PROPOSED CHANGES TO APPENDIX A

TECHNICAL SPECIFICATIONS

DRESDEN STATION UNITS 2 AND 3

SUMMARY OF CHANGES

Figure 6.1-1
OFFSITE ORGANIZATION

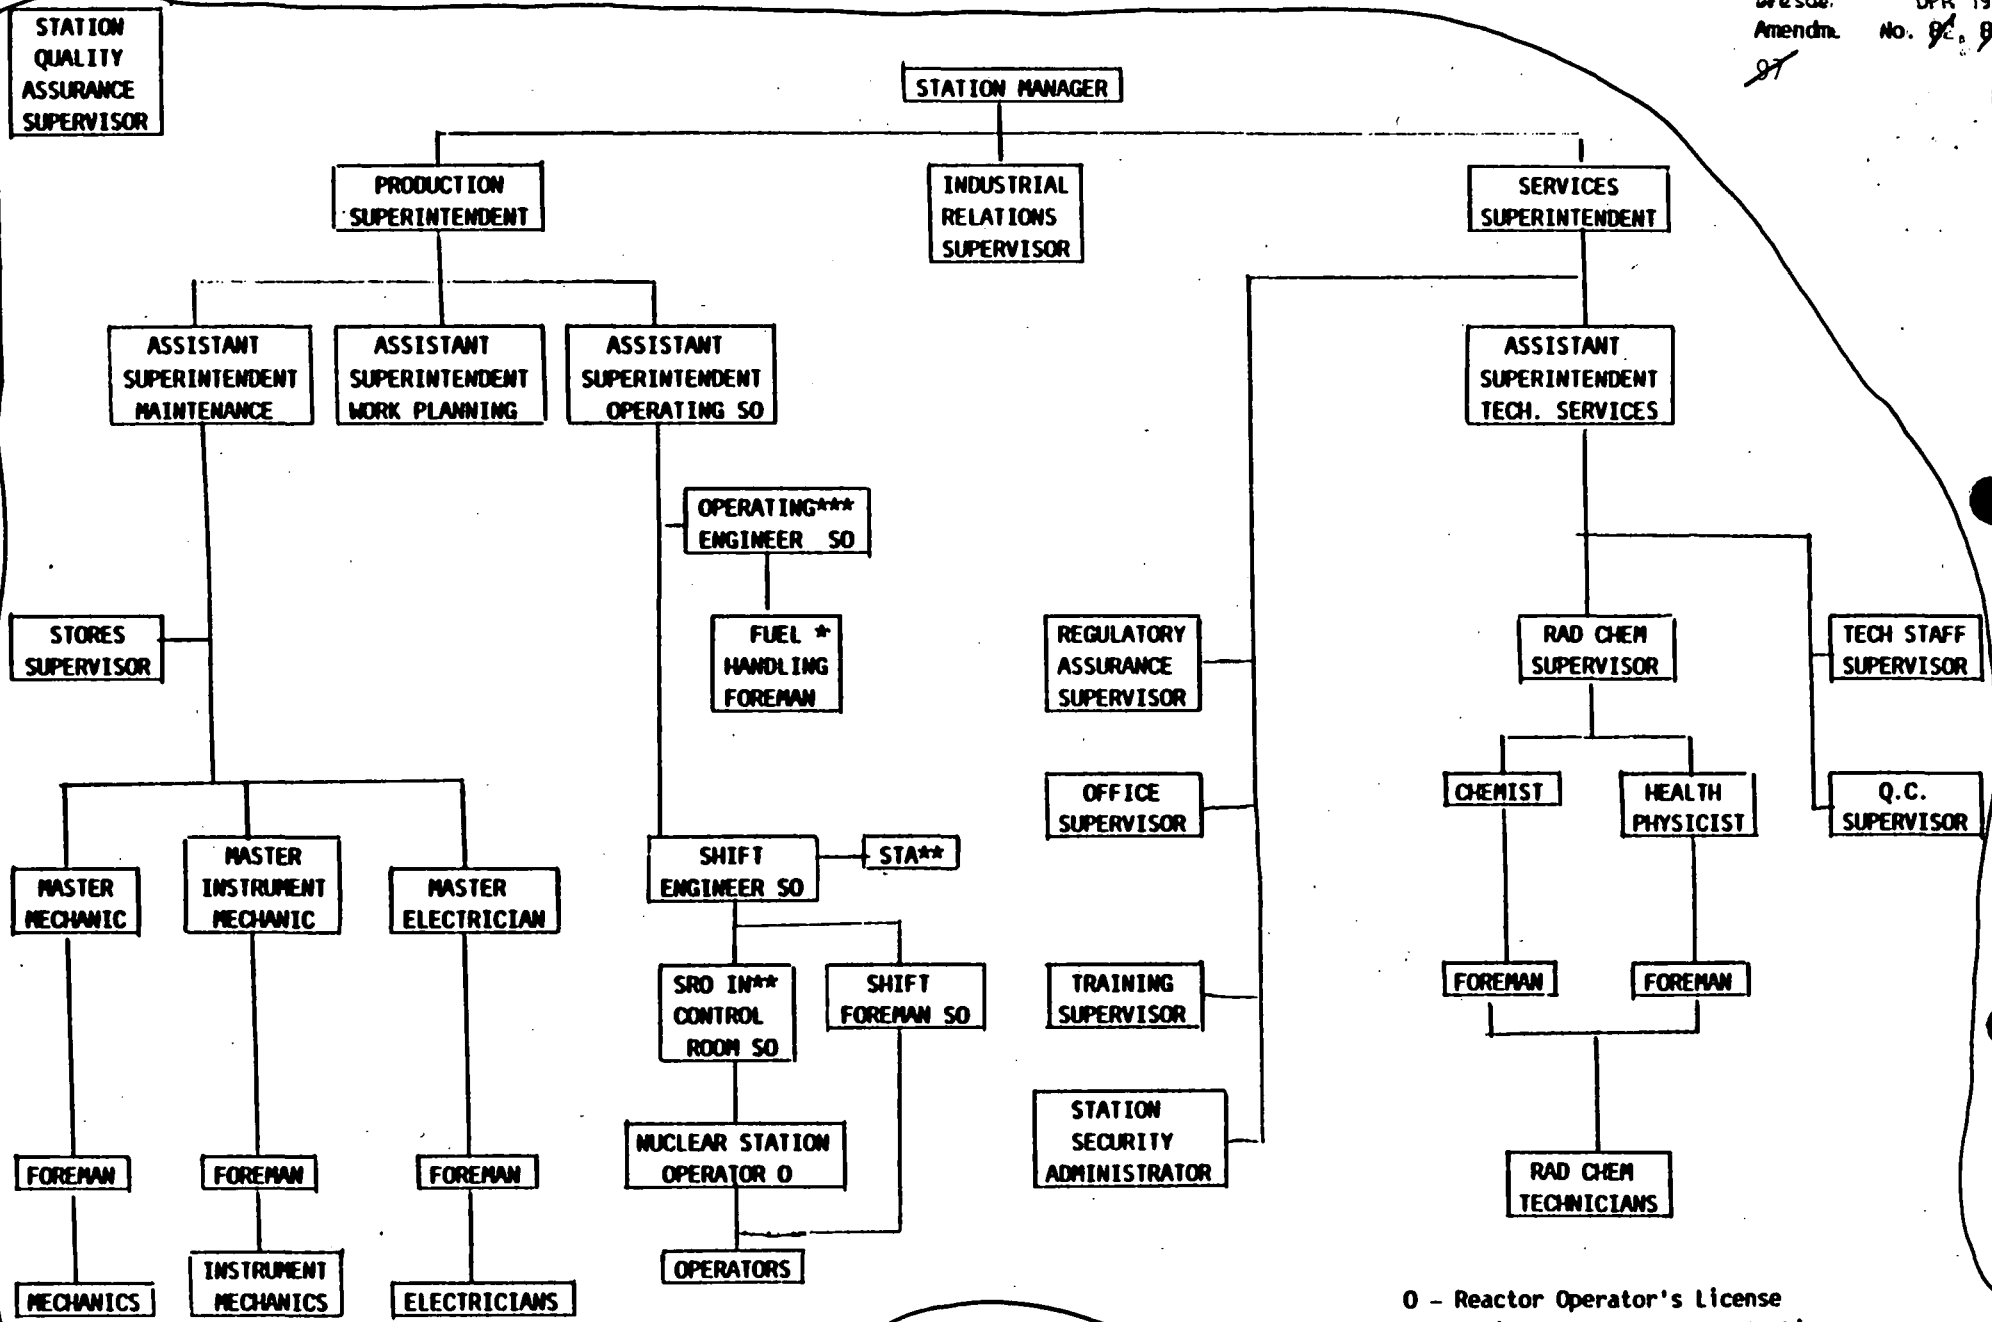
THIS PAGE IS INTENTIONALLY BLANK.
THE OFFSITE ORGANIZATION CHART HAS BEEN
REPLACED BY REFERENCE TO THE CECO QUALITY
ASSURANCE MANUAL.

- 2) Page 6-3/ Figure 6.1-1 -
 - a) Figure 6.1-1 has been deleted and the following statement has been added: "This page is intentionally blank. The offsite organization chart has been replaced by reference to the CECO Quality Assurance Manual."

The proposed change removes the organization charts since the appropriate charts are already contained in the Commonwealth Edison Company Corporate Quality Assurance Manual.

Figure 6.1-2

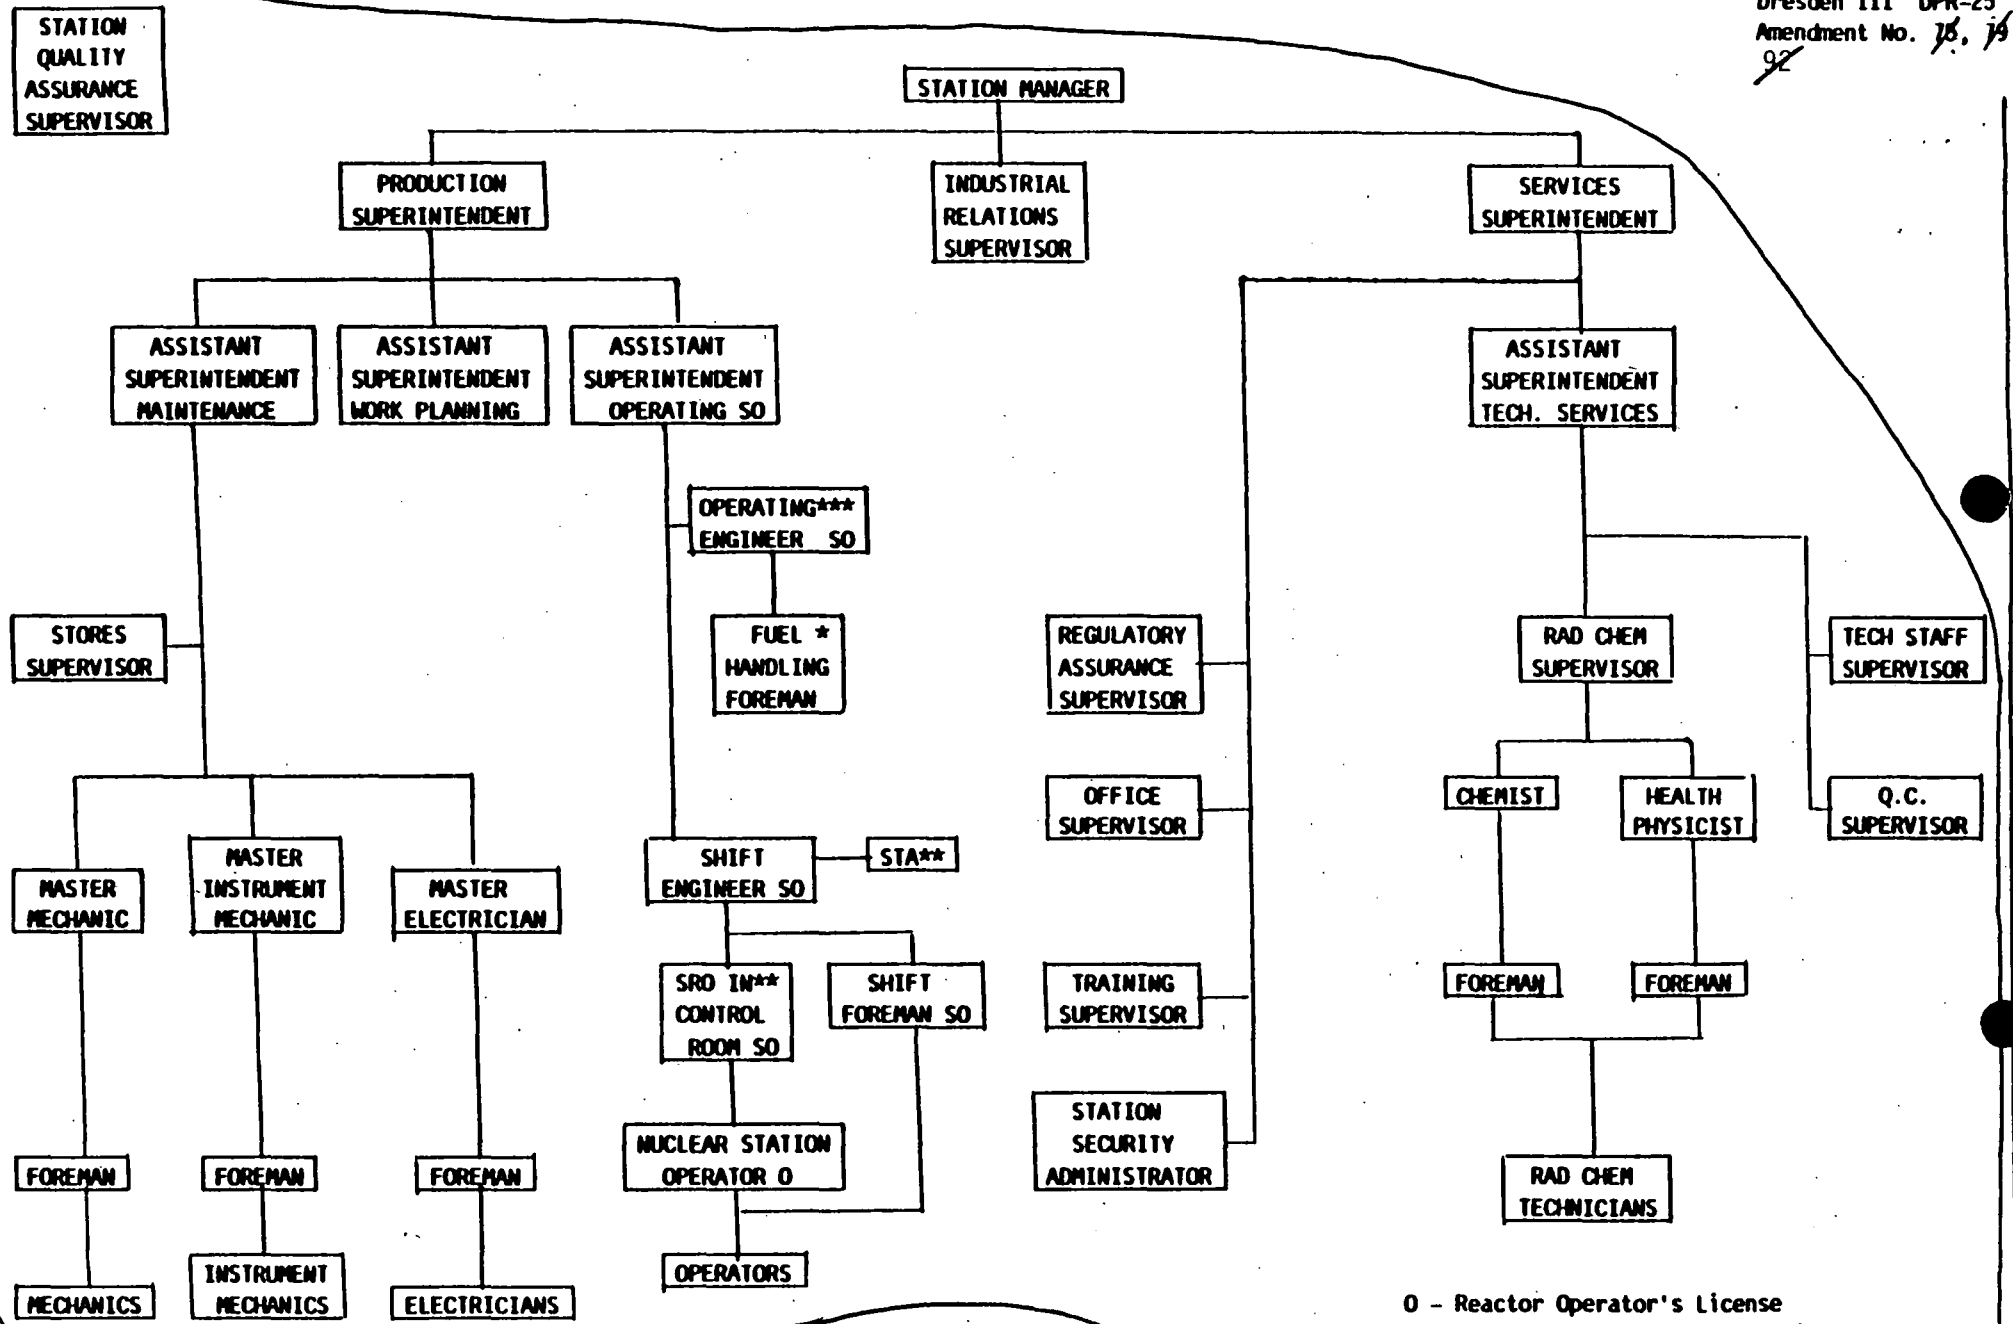
THIS PAGE IS INTENTIONALLY BLANK.
THE STATION ORGANIZATION CHART HAS BEEN
REPLACED BY REFERENCE TO THE CECO QUALITY
ASSURANCE MANUAL.

- 3) Page 6-4/ Figure 6.1-2 -
 - a) Figure 6.1-2 has been deleted and the following statement has been added: "This page is intentionally blank. The station organization chart has been replaced by reference to the CECO Quality Assurance Manual."
